PRODUCT/PROCESS CHANGE NOTICE (PCN)

PCN #: A1403-01 Product Affected: SOIC-28 Refer to Attachment II for the affected part numbers Date Effective: 3-Jul-2014	DATE 3-Apr-2014	MEANS OF DISTINGUISHING CHANGED DEVICES: <input type="checkbox"/> Product Mark <input checked="" type="checkbox"/> Back Mark Lot# will have a "A" prefix to denote alternate site, OSE Taiwan. <input type="checkbox"/> Date Code <input type="checkbox"/> Other
---	-------------------------------	--

PCN Type: Manufacturing Site - Alternate Assembly Location
Data Sheet Change: None
 No change in moisture sensitivity level (MSL)

Table 2: Comparizon of Package Outline Dimensions on the Existing Assembly and Alternate Assembly

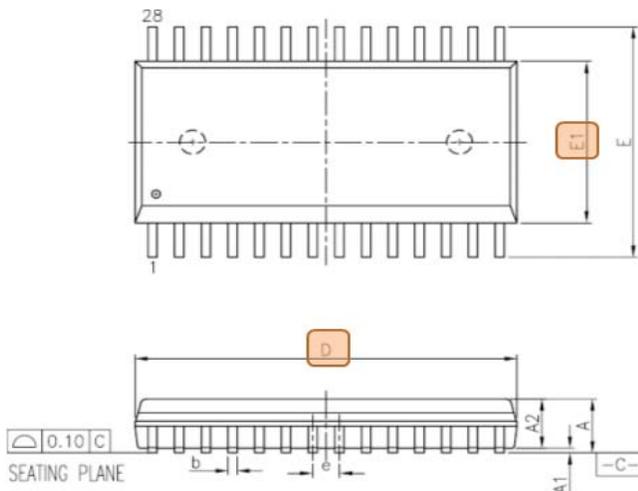
There are minor changes on the package dimensions as shown in Table 2.

POD SYMBOL	Unisem mils	OSE mils	Jedec mils	Remarks
D (body length)	718~728	697~733	697~733	No impact to design board footprint
E1 (body width)	340~350	324~350	324~350
